UNITED STATES PATENT AND TRADEMARK OFFICE

10/816,148

Office Action Summary	Application No. 10/816,148	Applicant(s) BODENSCHATZ ET AL.	
	Examiner Lori Amerson	Art Unit 3764

DETAILED ACTION

FIG. 6

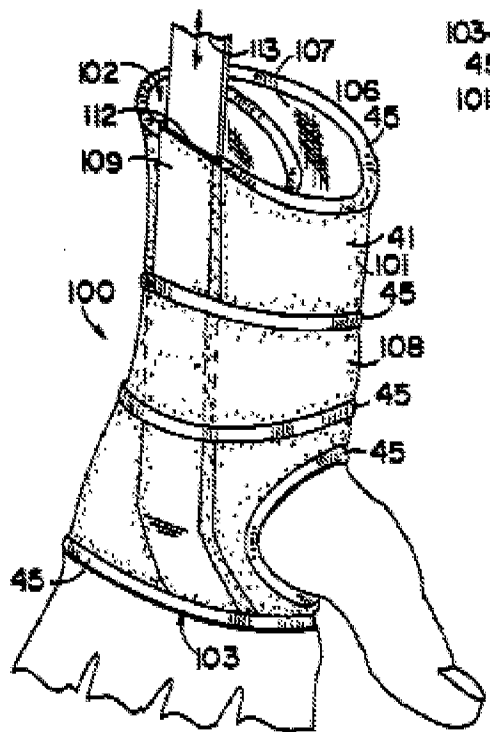
a. Claims 1-8 are rejected under 35 U.S.C. 103(a) as being unpatentable over Peters in view of Szlema. Peters discloses: an anatomically shaped section (see figure 2 below) which receives the wrist and the hand (see figure 6 below) and which is formed from a single piece of flexible and elastic material (see col. 2, lines 48-50) , the section narrowing (see fig. 2 below) in the proximal direction, the section having, on the medial edge, a cutout for receiving the thumb 104, and with at least two straps 105,108 secured on the medial edge, which straps can, be secured on the dorsal side of the bandage (see col. 4. lines 11-21), and with a pocket 110 which is secured on the palmar side of the bandage (see col. 3, line 58-68 thru col. 4, lines 1-10), in particular sewn (col. 2, line 25) thereon.
